SERVICE INSTRUCTION

RUNNING MODIFICATIONS ON

ROTAX® ENGINE TYPE 912/914 (SERIES)

SI-912-020R11

fig. 3

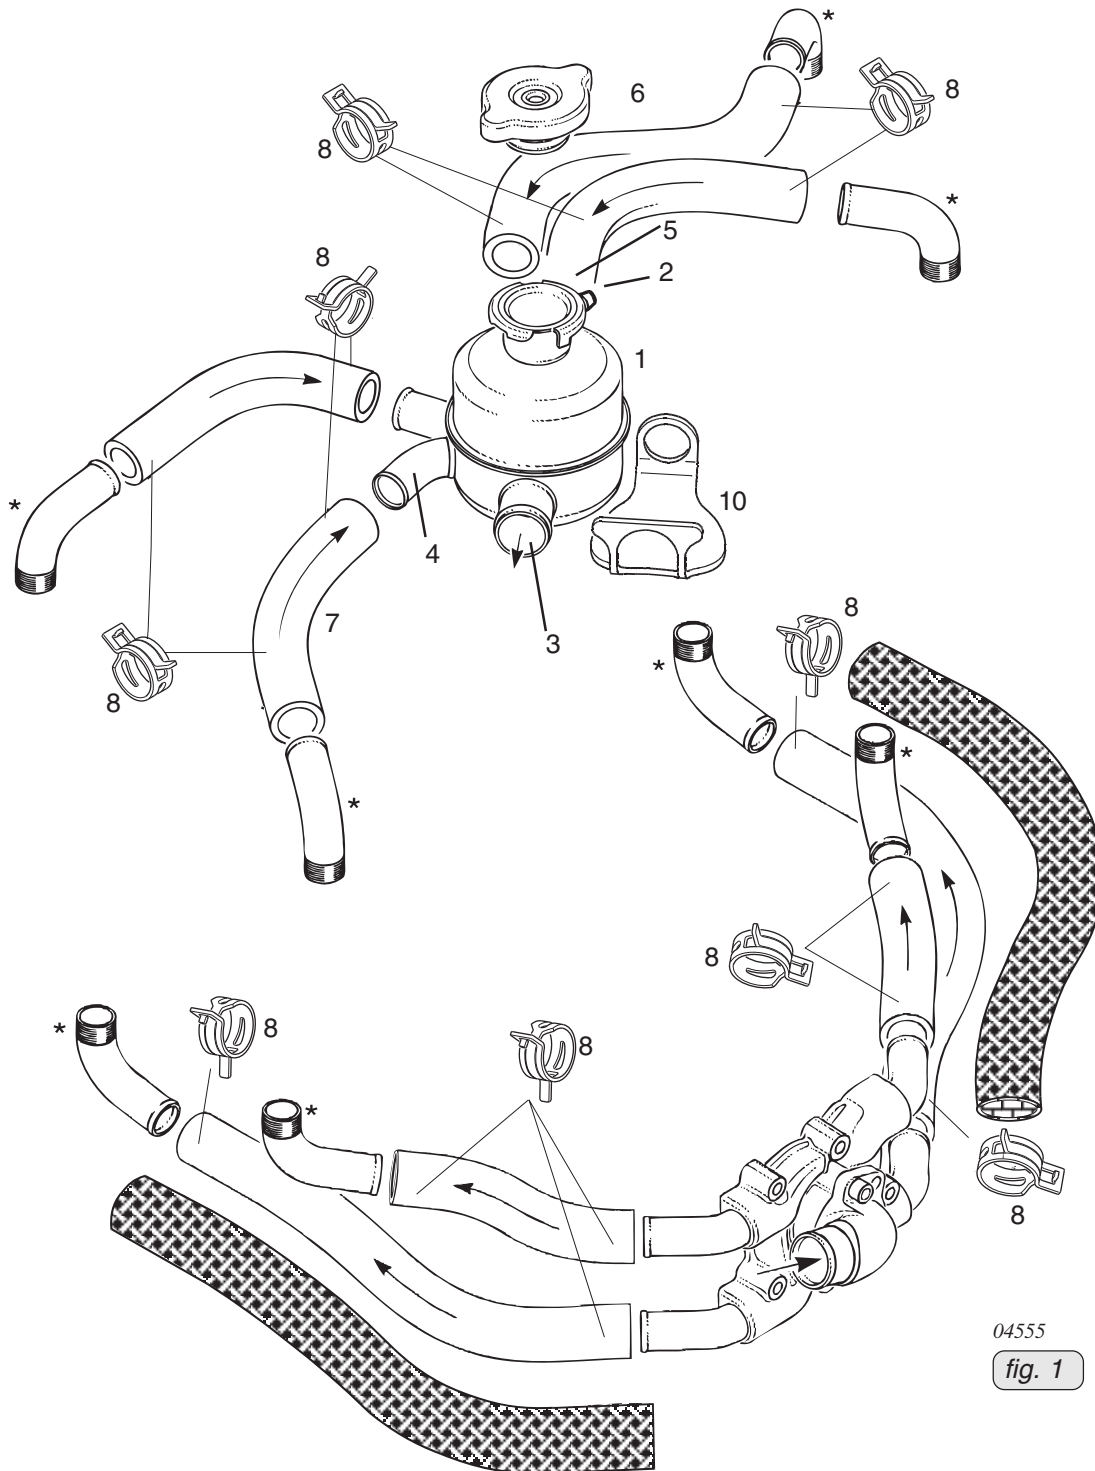
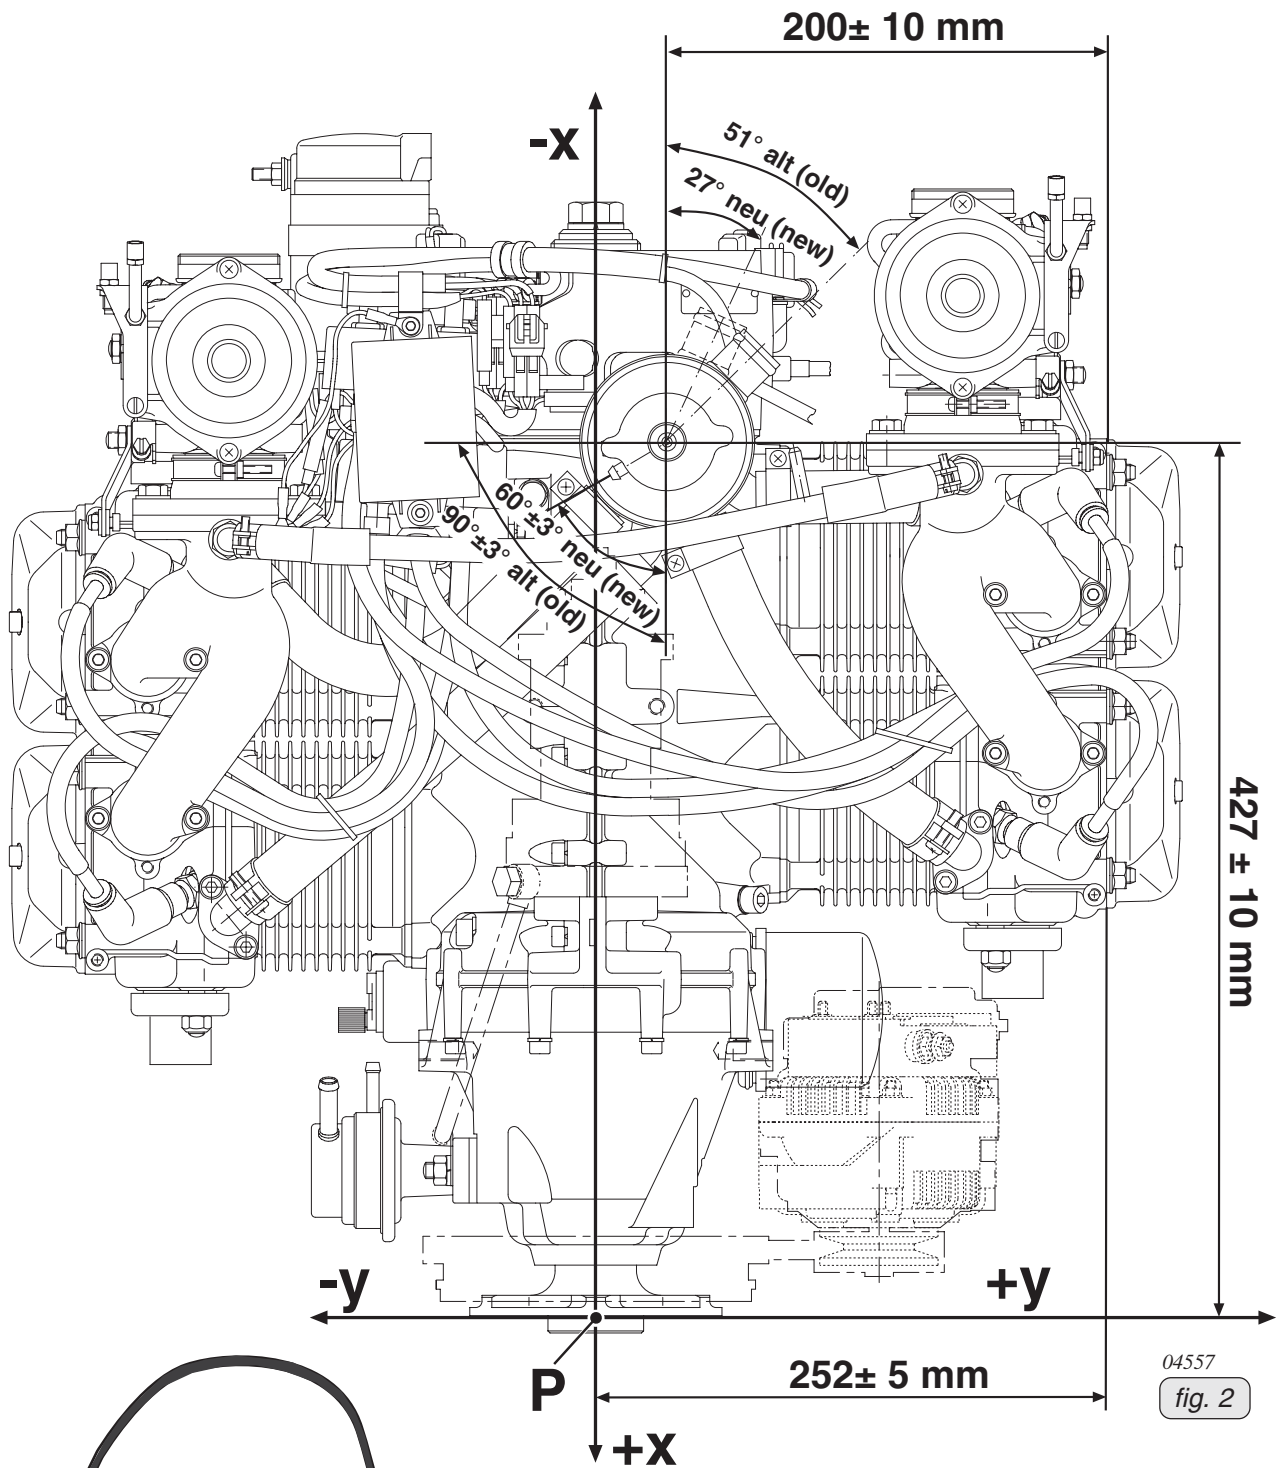
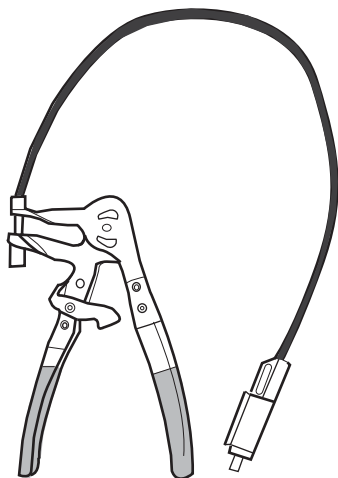
In the course of further development and standardization the position of the expansion tank (1) has been optimized!

- position of connection (2) to overflow bottle (from 0° to 30±3°)
- position of connection (3) to radiator (from 51° to 27±3°)
- angle of inlet socket (4) from cylinder 4 (34° inclined)
- length of inlet socket (5) from cylinder 3 (length increased by 13,4±3 mm)
- length of coolant hose (6) from cylinder 1 (length increased from 270 mm to 285 mm)
- length of coolant hose (7) from cylinder 4 (shortened from 100 mm to 85 mm)
- new spring type hose clamps (8) to attach the coolant hoses (expansion tank and water pump)

- Install the coolant hose (6) 285 mm to cylinder 1 and the new coolant hose (7) 85 mm to cylinder 4. For attaching all the coolant hoses from expansion tank, water pump, cylinders, use the new spring type clamps.

■ **CAUTION:** Take care of appropriate slip-on length of the coolant hoses on the corresponding connection socket. Verify tight fit of clamps and hoses and check for leakage. Always fit the clamps such that they can not wear on any component and use a suitable tool (see fig. 3) for fitting them.

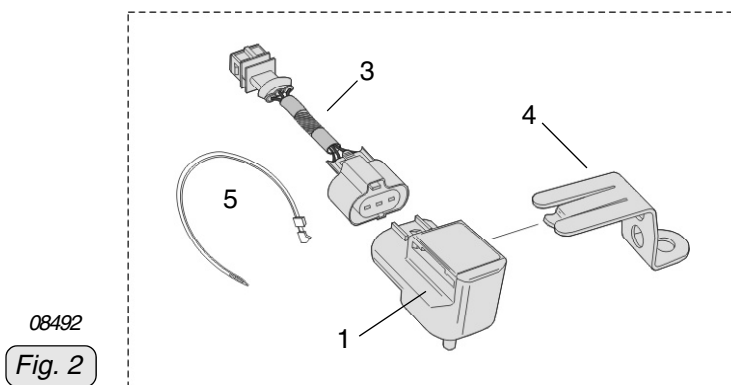
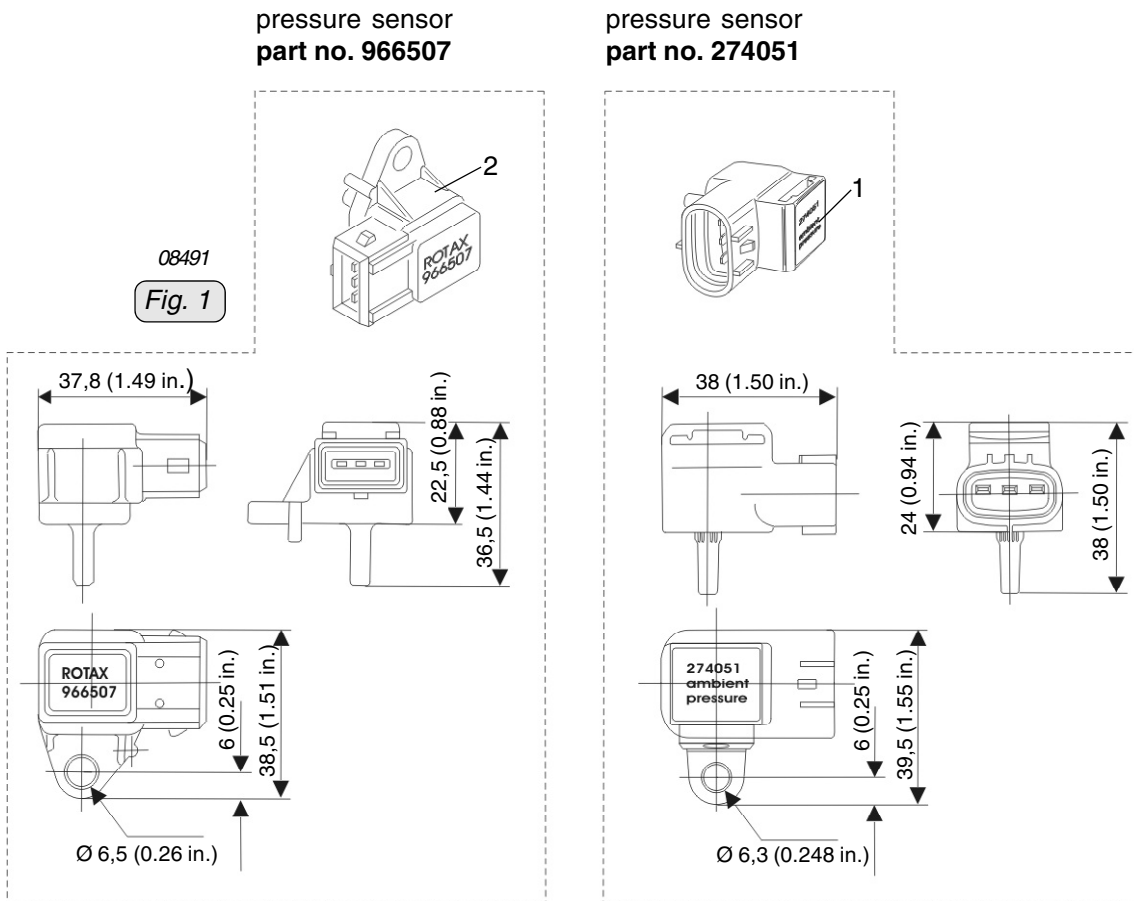
Due to the termination of production of the ambient pressure sensor (part no. 966507) a new ambient pressure sensor part no. 274051 has been introduced. The new ambient pressure sensor is of different size and also has a different connector. The connection for the wiring harness had to be changed.

1. Disconnect the pressure sensor (2) from the wiring harness.
2. Connect adapter cable (3) to wiring harness and to the new pressure sensor (1).
3. Install bracket (4) onto pressure sensor.

4. Position adapter cable and secure with cable binders (5).

new Version

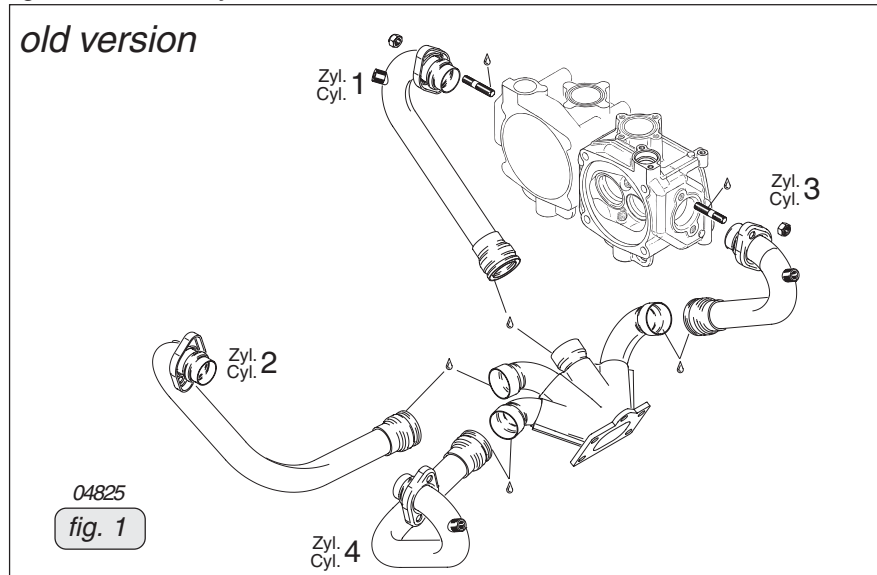
Owing to continuous further development, the exhaust bends were slightly re-worked. The couplings were optimized for their position.

- Position of the EGT connections (6) to the exhaust bends for cylinders 3 and 4 were routed such that installation of the new drip trays is possible.

◆ NOTE: If replacement of any single old part number is necessary, you must replace it with the same old part number. If the old part number is not available, the **entire** assembly including all 4 pipes and manifold must be replaced with new part numbers. New style pipes and manifold are not interchangeable with old style.
